260-C-18
Hillcrest Ave.
Street Extension
Tim Higgins

Project Name: Hillcrest Avenue Street Extension/SF Home
Applicant: Tim Higgins, Higgins Builders
Planner: Nell Donaldson/Phil DiPierro

This letter is in response to review comments contained in your letter dated July 29, 2013.

Thank you for submitting an application for the construction of approximately 150' of Hillcrest Avenue and the associated single family home. The Planning Authority is evaluating this proposal as a preliminary plan subject to the following applicable Land Use Code provisions:

Drawing Name:	Site, Utility, Grading and Drainage Plans
Project:	Hillcrest Avenue Single Family Residence Portland, Maine
Client:	Timothy Higgins 83 Bay Street, Portland Maine 04104

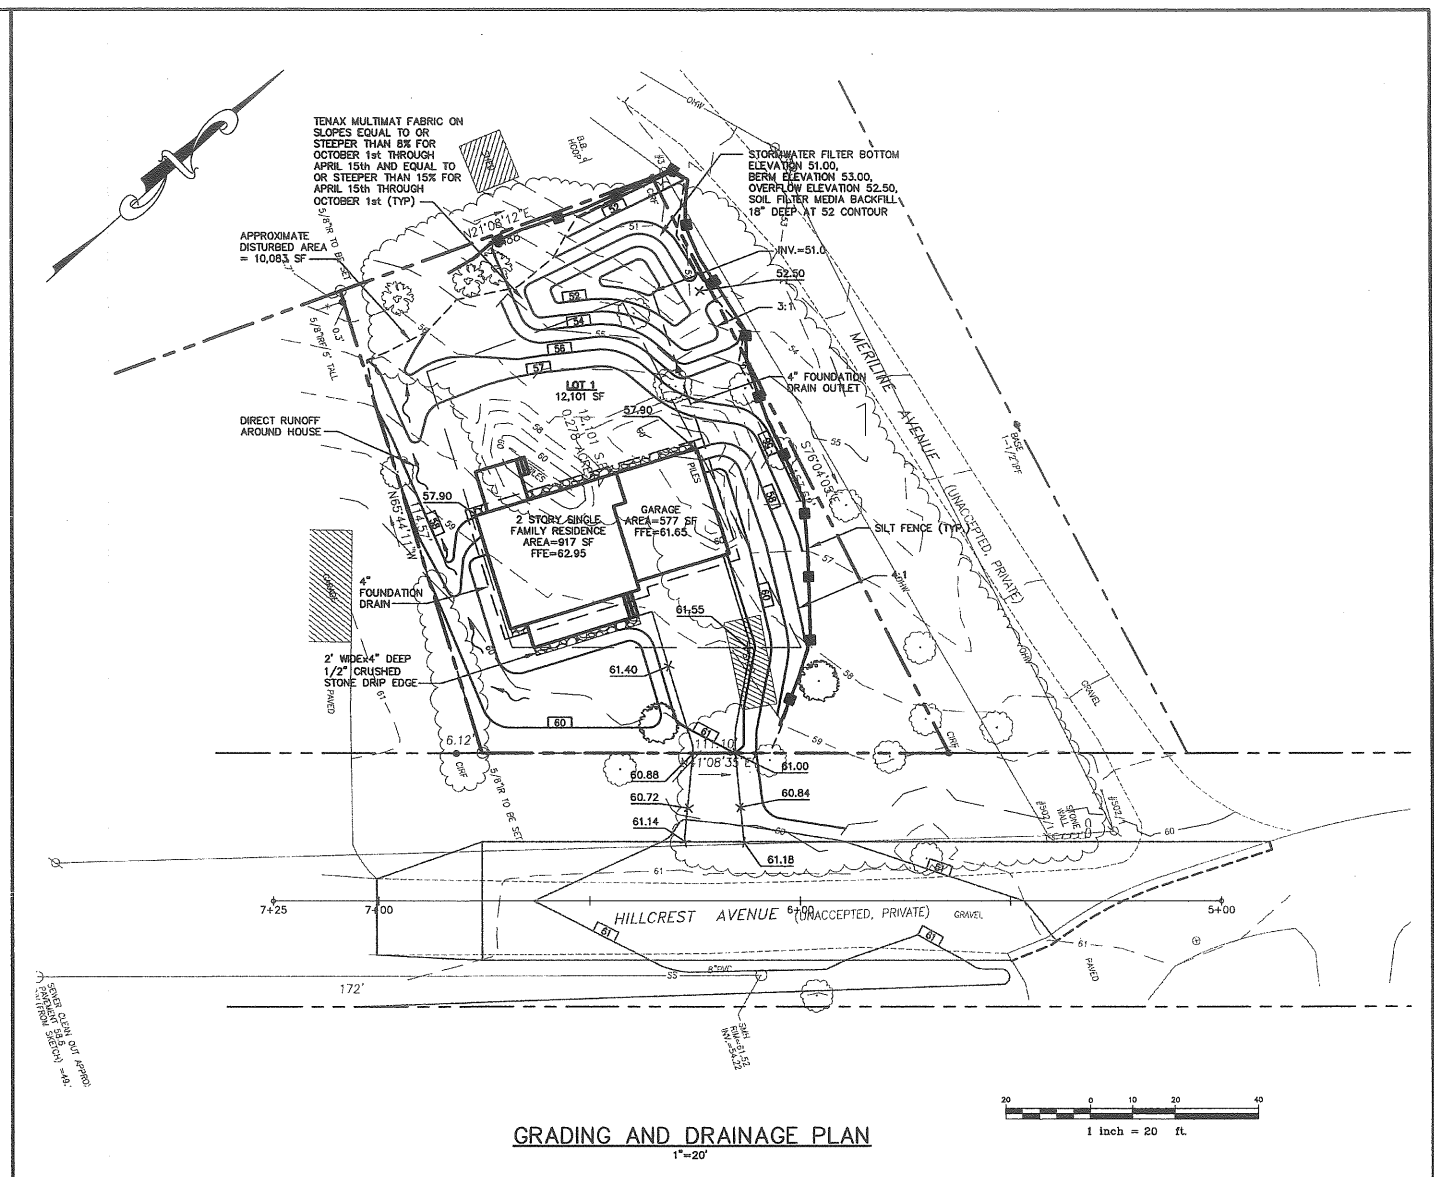
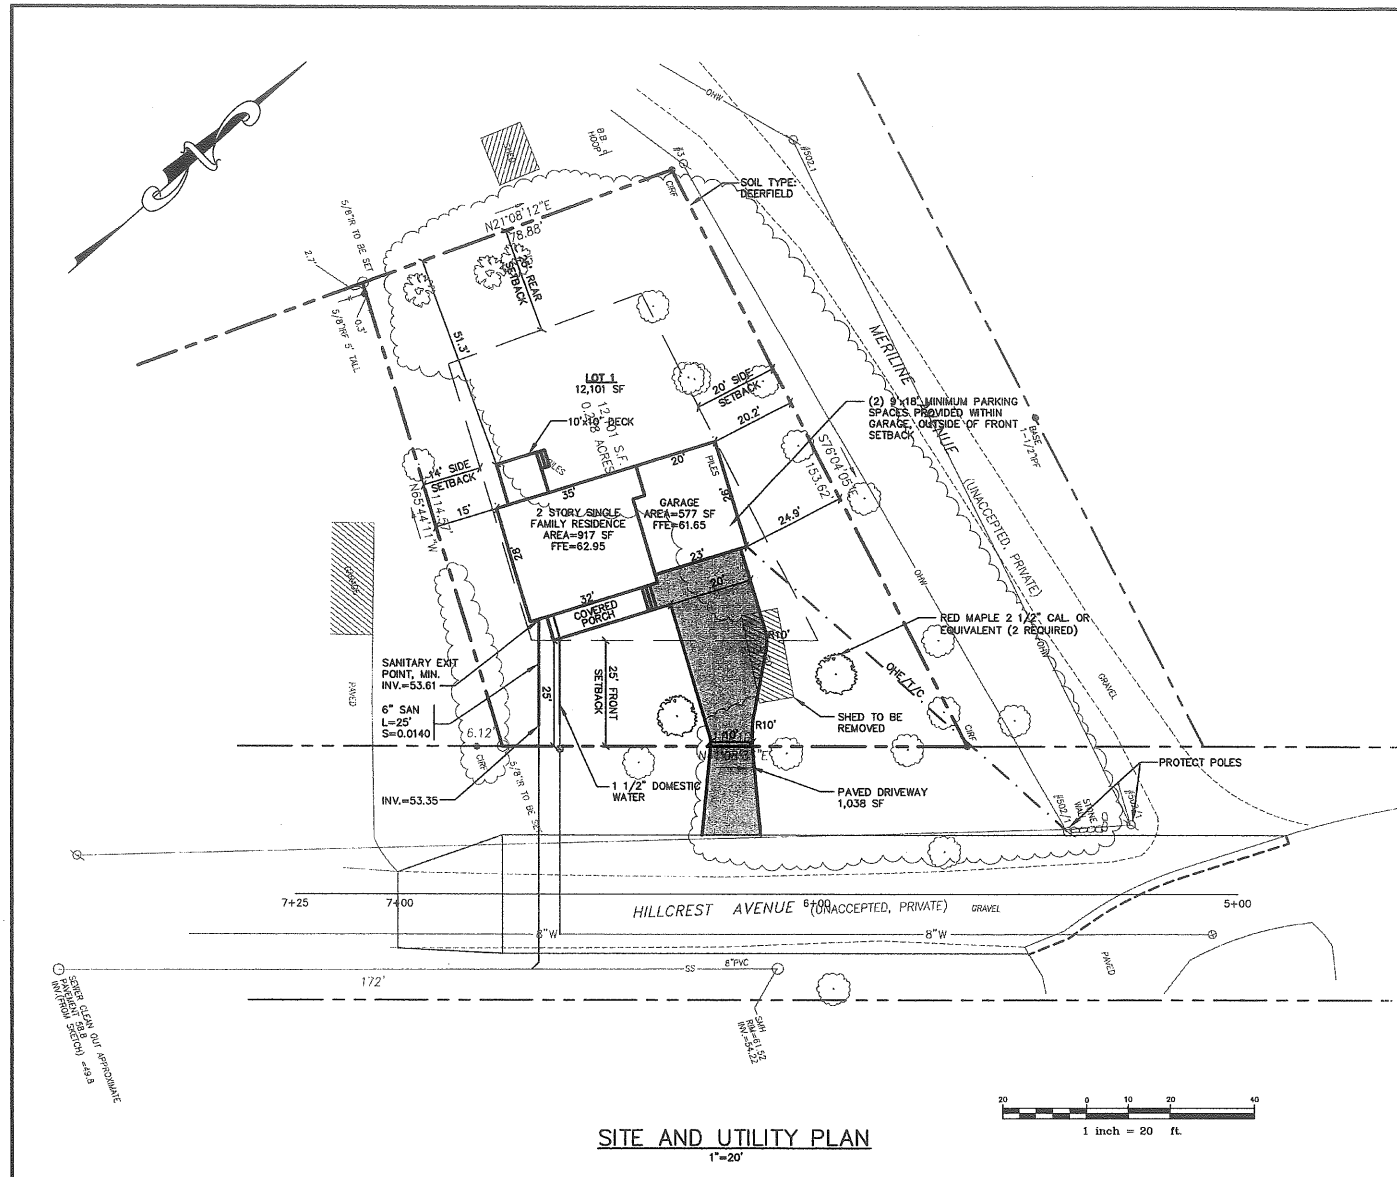
- 2. The Stormwater Management Plan will need to include a stormwater inspection and maintenance plan for all stormwater BMP's designed to meet the General Standards, developed in accordance with and in reference to MaineDEP Chapter 500 guidelines and Chapter 32 of the City of Portland Code of Ordinances.*

- 1. Please revise the grading plan so that it is clear that neighboring properties are not negatively impacted by stormwater surface drainage, ie adding drip edge around the foundation, berming and swaling so that stormwater is directed to a drywell or stormwater infiltration area, rain garden, etc.*

- 1. In addition, per the request of zoning, please revise the site plan as necessary to match the size of the deck shown on the associated building plans.*

Response: Stormwater inspection and maintenance notes have been added to the single family residence plan sheet.

Response: Grading has been revised, a drip strip and a filtration BMP have been added.

Response: The deck size has been revised.

Drawing Name: **Hillcrest Avenue Plan and Profile**
 Project: **Hillcrest Avenue**
 Portland, Maine
 Client: **Timothy Higgins**
 83 Bay Street, Portland Maine 04104

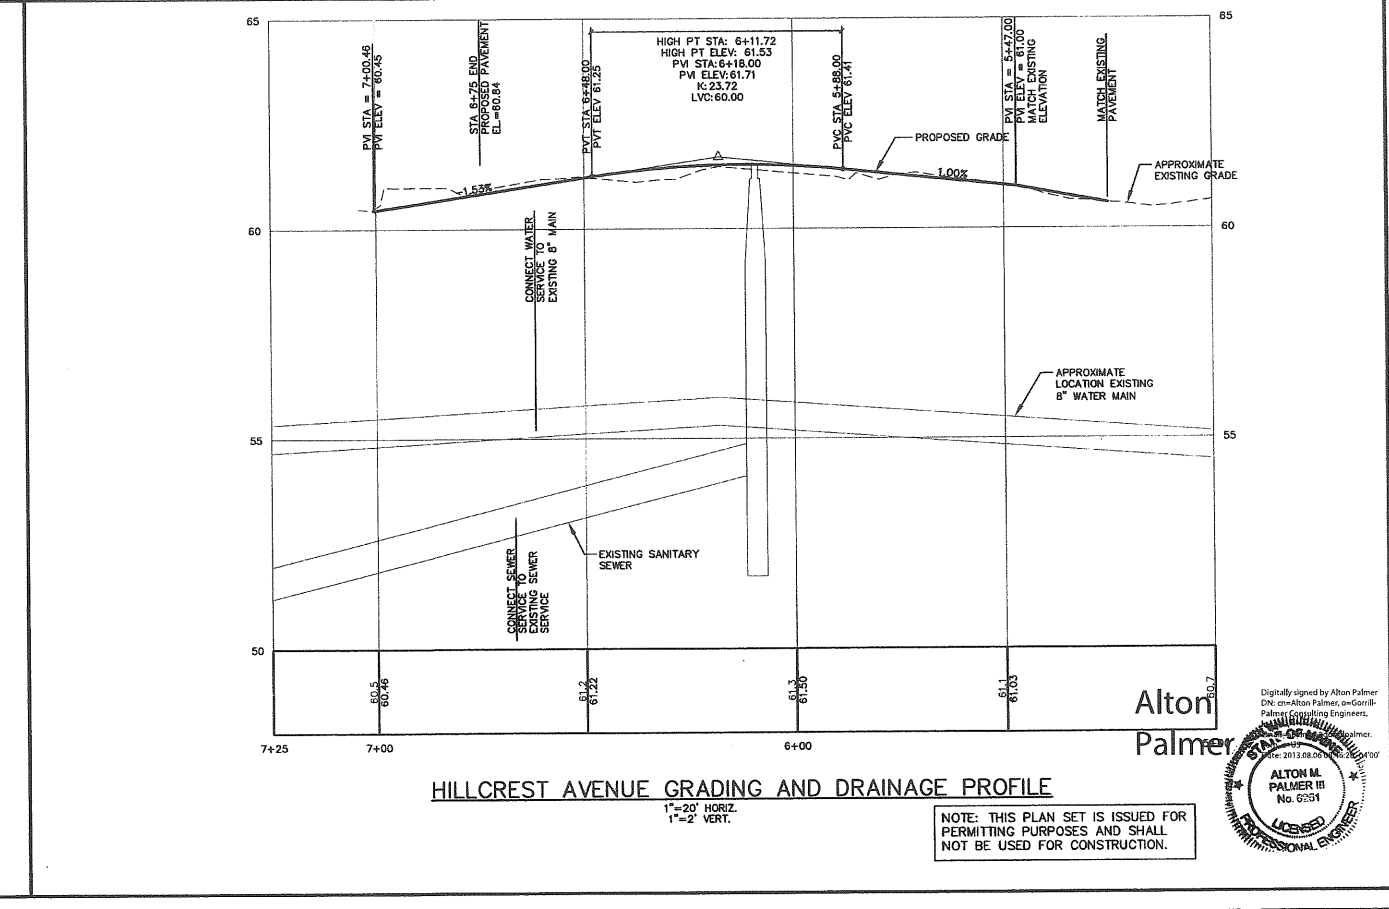
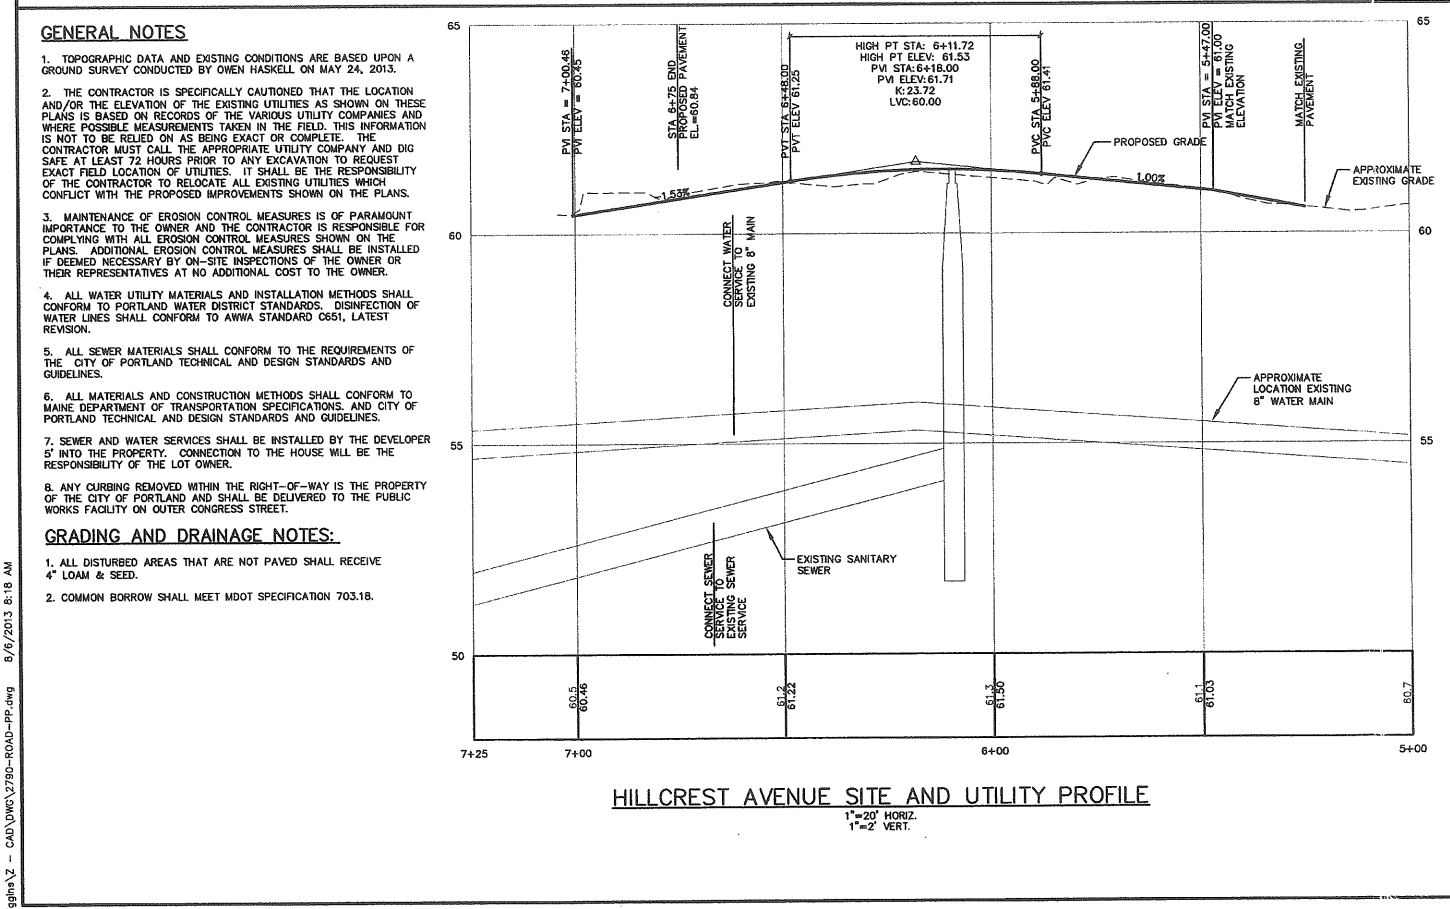
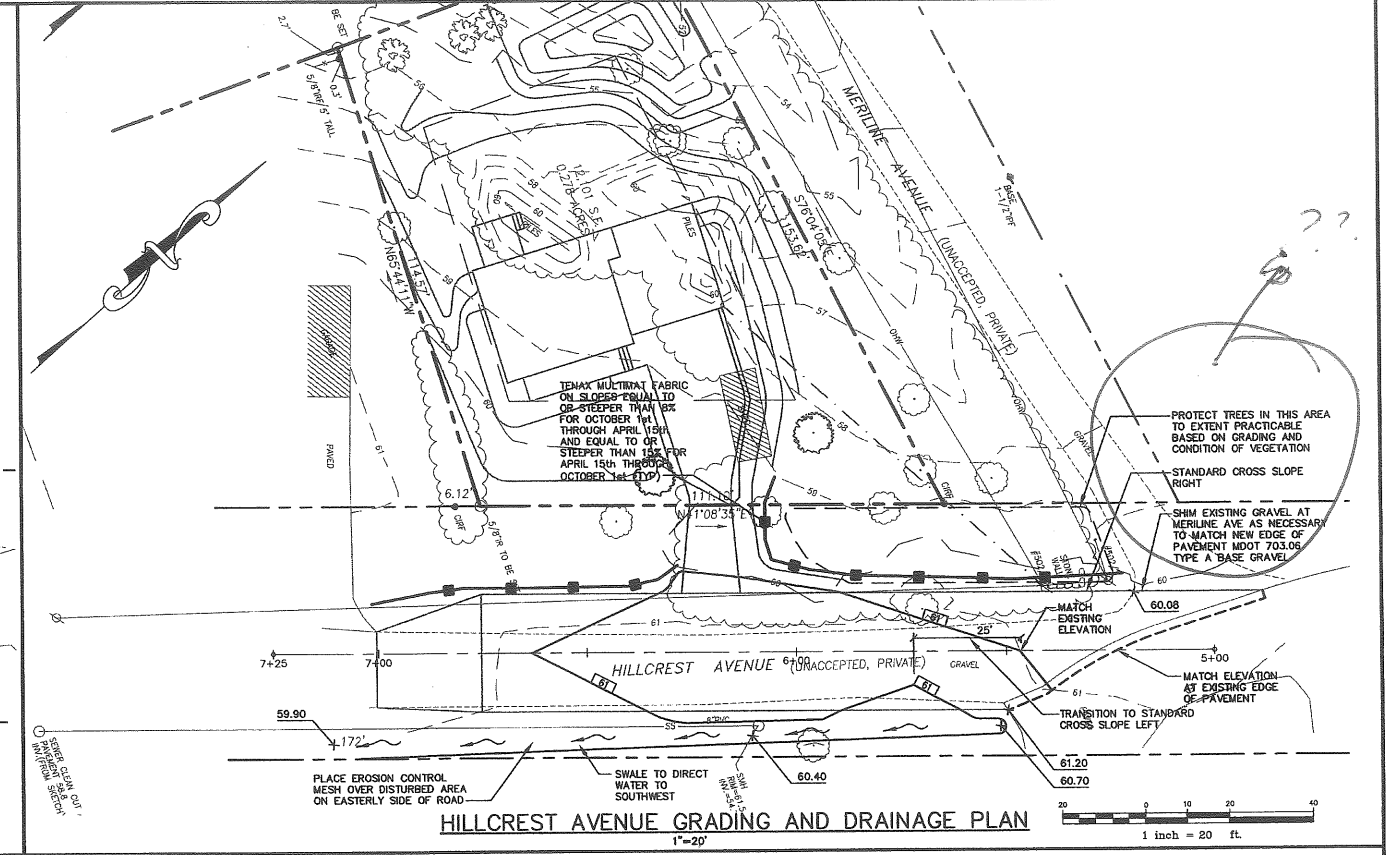
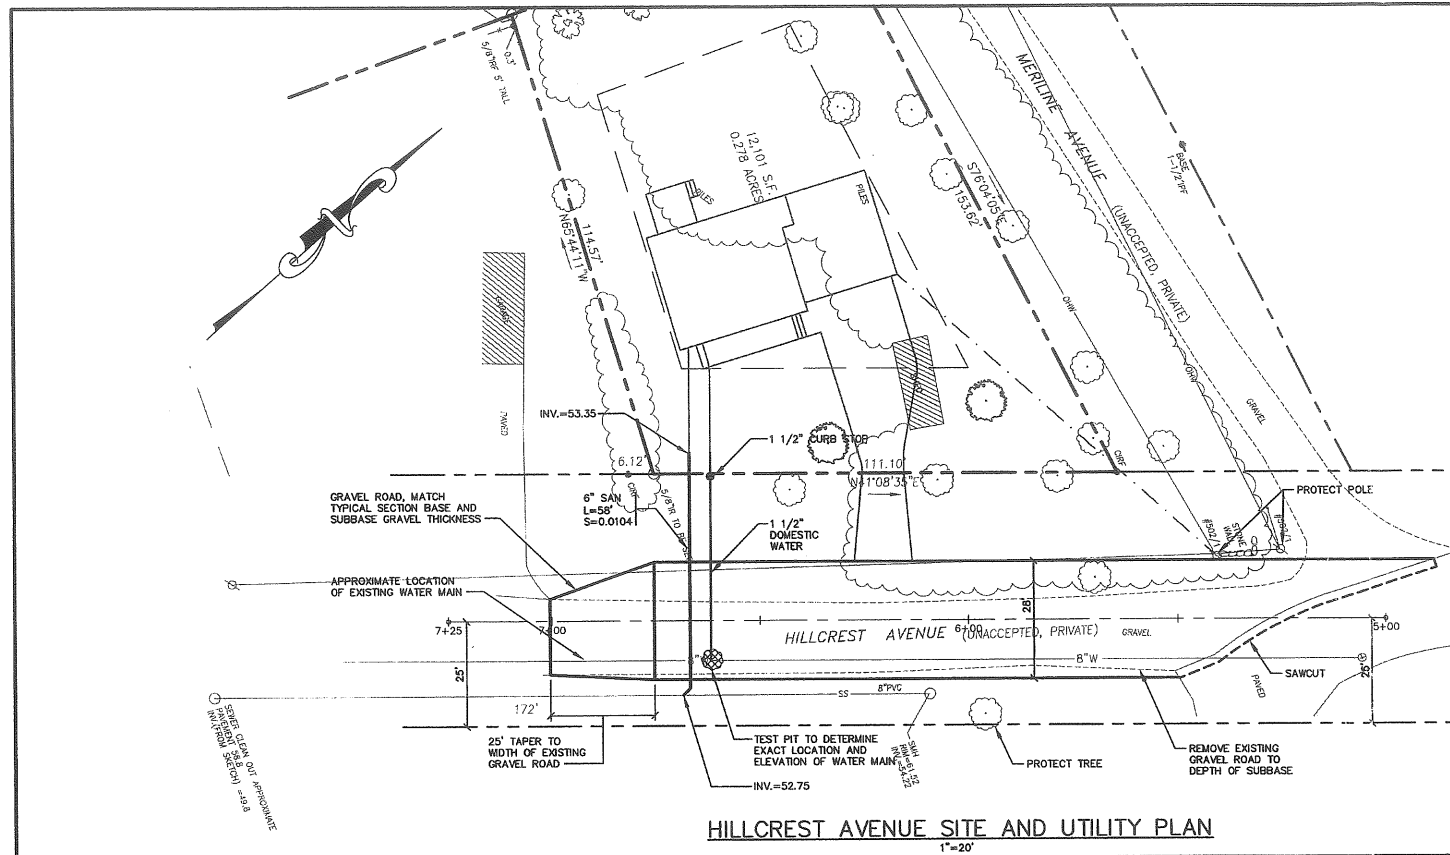
- 2. In conversations on site, the applicant has indicated that the existing tree stand north of the proposed roadway will remain largely intact, thereby satisfying the street tree requirement. Please Identify tree saves and/or tree save areas in the revised plans.*

- 4. The Applicant has proposed to construct a swale on the eastern side of Hillcrest Avenue to direct runoff to the southwest. Additional information should be provided, such as stabilization requirements for the swale and any downhill areas not shown on the plan.*

Response: The tree save areas have been added to the roadway plan.

Response: A note to install erosion control mesh over the disturbed area on the southeasterly side of Hillcrest Avenue has been added to the roadway plans.

TYPICAL LOCAL RESIDENTIAL STREET
NOT TO SCALE

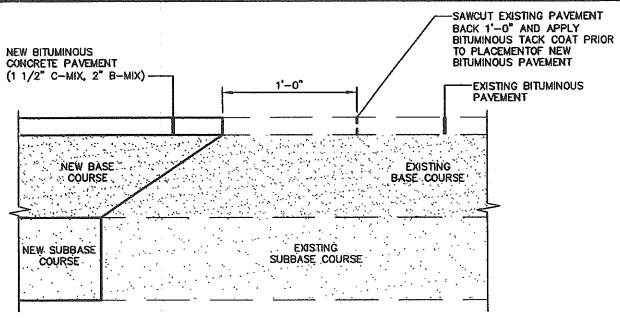
- 3. The Applicant has requested a waiver from the requirement to install underdrains within the proposed street, as the existing, unaccepted and private portion of Hillcrest Avenue does not appear to have underdrains. DPS will need to provide a determination on this waiver request. If the waiver is granted, the Typical Residential Roadway Cross Section detail should be revised to not include underdrains. Note that the Department of Public Services has indicated that they are willing to waive the underdrain requirement.*

Response: The underdrains have been removed from the detail.
